ART 1/2 MODIFICATION NOTE 20 (for Electronics Technicians)

SUBJECT	: Replacement of the abort switch in the ART Remote Control Unit (RCU).						
PURPOSE	: To provide installation instructions for a larger replacement switch when the current switch fails.						
EQUIPMENT AFFECTED	: All ART systems in the CONUS, Alaska, and Pacific regions.						
PARTS REQUIRED	: The following parts may be ordered through the National Logistics Support Center (NLSC):

The current abort switch in the ACU is no longer manufactured. This modification note contains instructions for the replacement of an old defective abort switch (P/N 900115-02) with the newer, slightly larger switch.

Card Cage Assembly

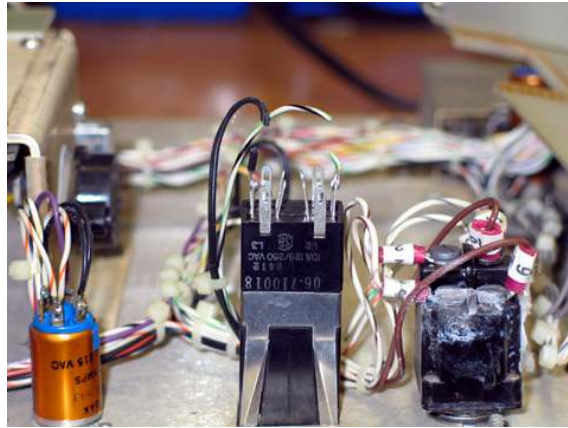
1. Turn off electrical power to the RCU (5A1).
2. Remove eight screws around the outside edge of the front panel (5A2H243 through 5A2H250) and lower RCU front panel (5A1) (see Card Cage Assembly).
3. Remove the five Phillips head screws securing the card cage assembly to the front panel (400067-31).
4. Remove the card cage assembly from the front panel.

Cut Wires

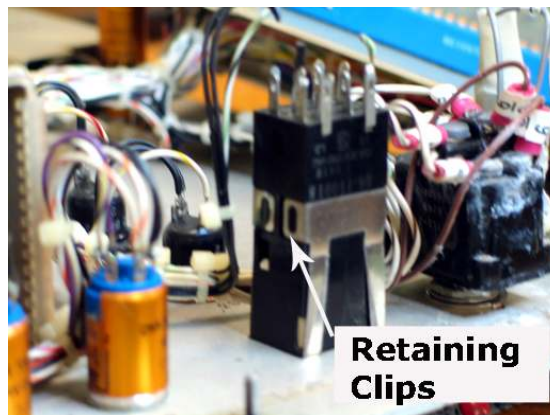
5. Cut the color coded electrical leads to the abort switch, see attached Cut Wires photo.

Retaining Clips

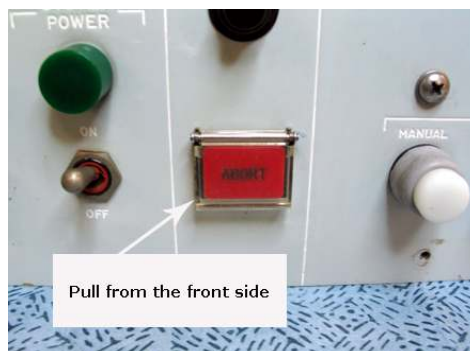
6. Remove the two switch retaining clips by sliding a small screwdriver underneath one edge of the clip and push/rotate toward the plastic keeper.
